TechInfo Sheet

Product Group: Hi-Fi Audio

Model: CR20 (CD Changer mechanism)

Subject: Disc spacer comes off

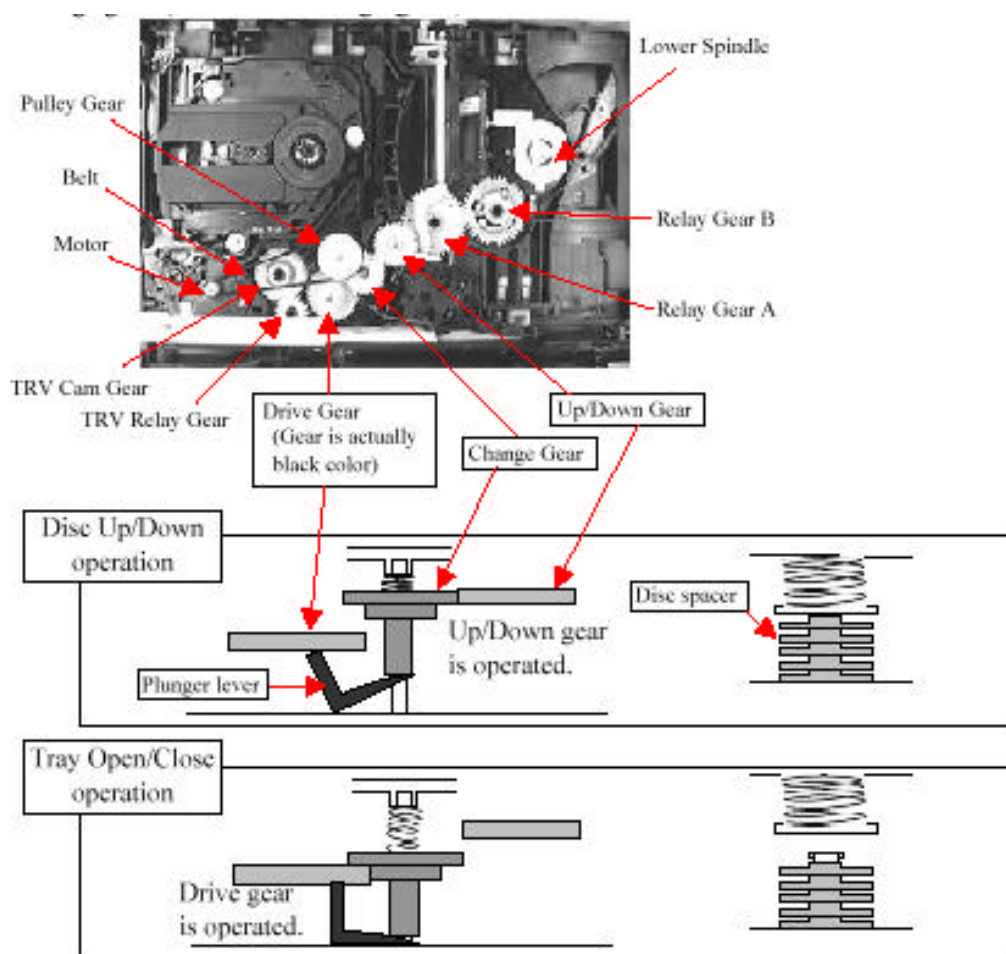
Cause: This mechanism controls the switching of Disc Up/Down and Tray Open/Close operation using the Change gear. (Refer to following diagrams)
If the Change gear does not drop down due to tight engaging between the Change gear and Drive gear when switching to Tray open/close operation, the disc spacer will come off.

Original	New
RMB0549	RMB0549-1

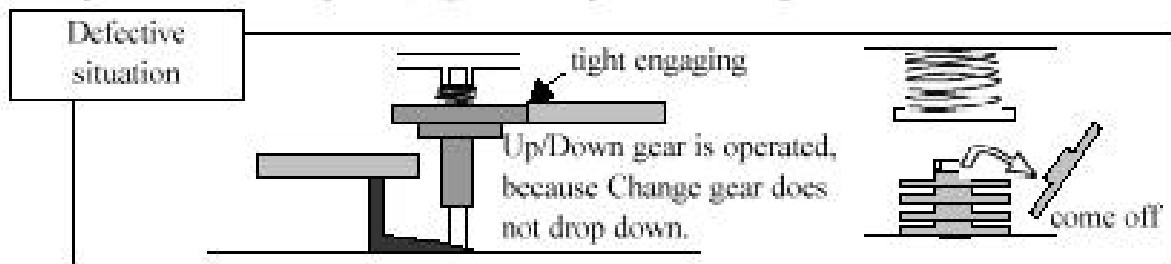
Remedy: Replace the Change gear spring to a stronger one.
